BOROUGH OF OCEANPORT PLANNING/ZONING BOARD

REGULAR MEETING • AGENDA

OCTOBER 14, 2025 at 7:00 PM

5. **Roll Call**
6. **Board Business**
7. **Approval of Minutes**
8. **Resolutions**
9. **Old Business**
10. **New Business**
 - 10.1. PB2025-14 Vincent Coccimiglio
Block 127, Lot 9
25 Springfield Avenue
Proposed reconstruction of a non-conforming single family home

- Plan entitled "Greco Residence" prepared by Shissias Design + Development dated November 11, 2024, consisting of three (3) sheets;
- Plan entitled "Map of Property" prepared by DMC Associates, Inc., dated January 23, 2020, consisting of one (1) sheet.

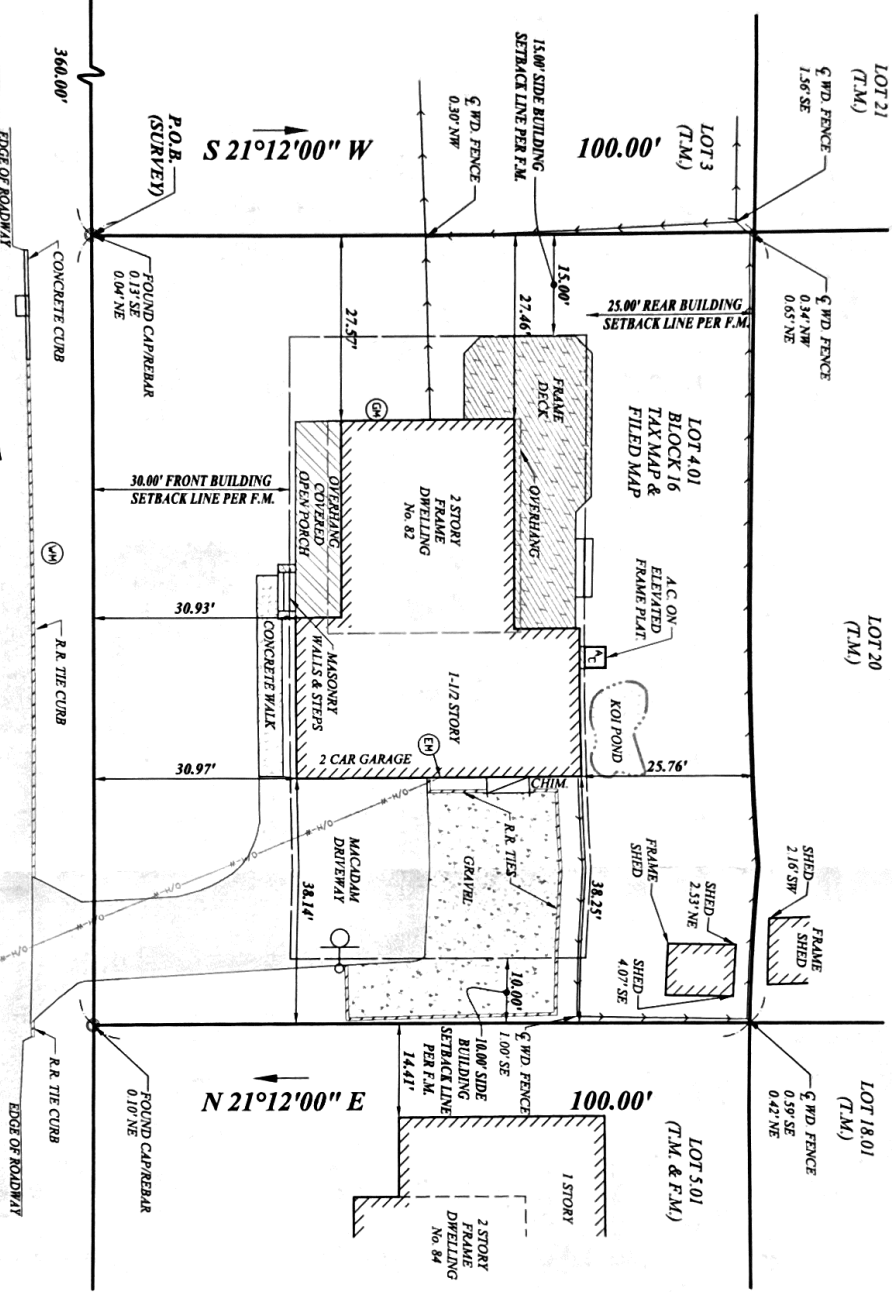
1. The applicant shall clarify if the 2020 survey is representative of current conditions.
